Superfund Record of Decision:

Miami County Incinerator, OH

REPORT DOCUMENTATION PAGE	1. REPORT NO. EPA/ROD/R05-89/094	2.	3. Recipient's Accession No.
4. Title and Subtitle SUPERFUND RECORD OF DECISION Miami County Incinerator, OH First Remedial Action - Final			5. Report Date 06/30/89

**FIGURE 3
ADDITIONAL MONITORING WELL
INSTALLATIONS
MIAMI COUNTY INCINERATOR
RECORD OF DECISION**

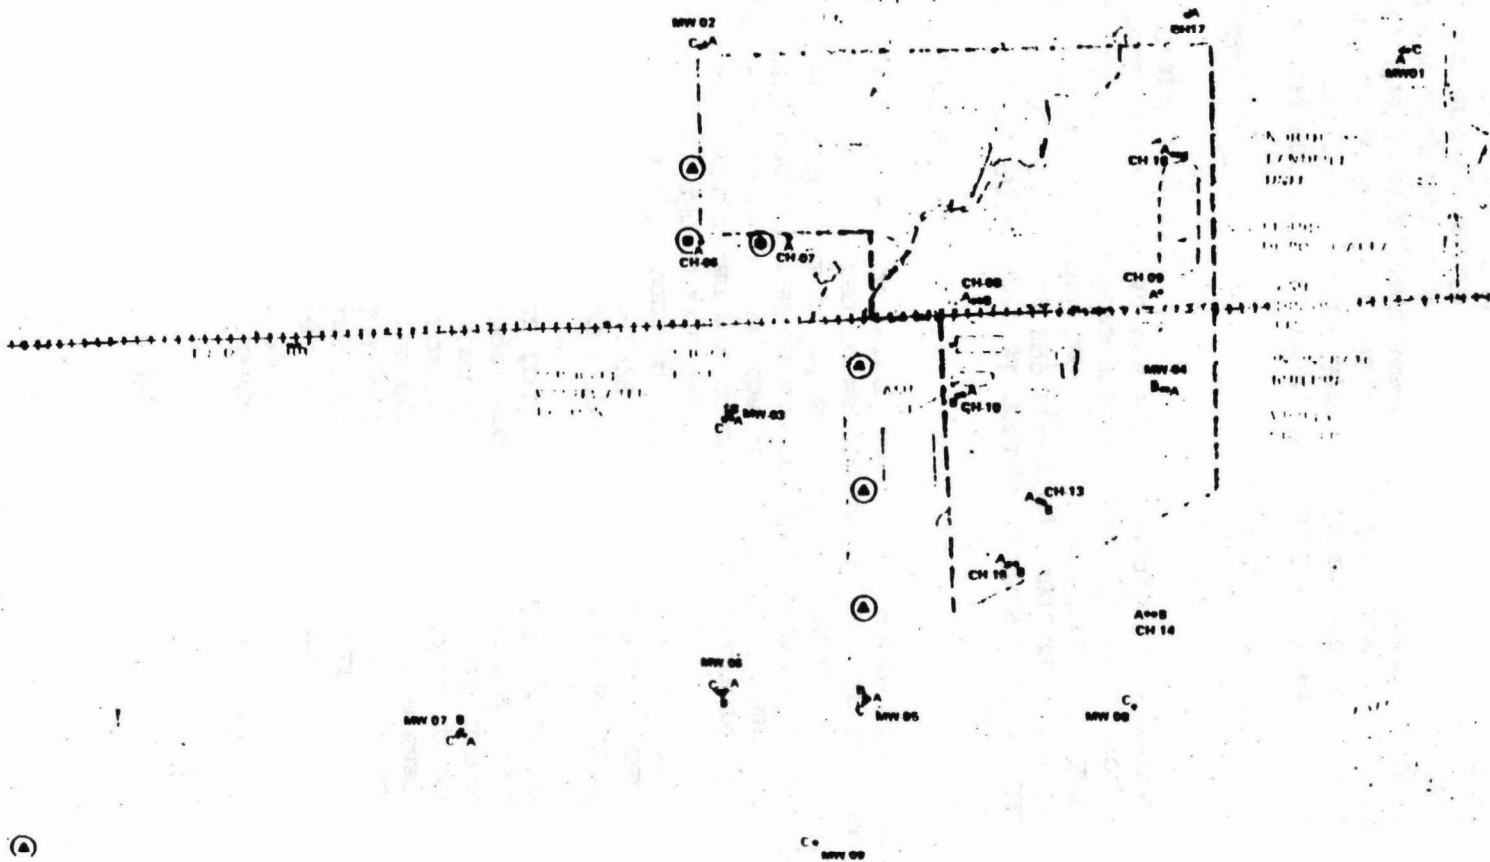
In addition to the monitoring network that is in place, additional groundwater monitoring will be required. At a minimum, this will include monitoring locations as presented in Figure 3.

South Landfill. A monitoring well cluster (one monitoring well in the upper aquifer, and one monitoring well in the lower aquifer will be installed on the south edge of the south landfill, see Figure 3). An additional monitoring well will be installed in the upper aquifer at the location CH-06. A monitoring well will also be installed in the lower aquifer at location CH-07.
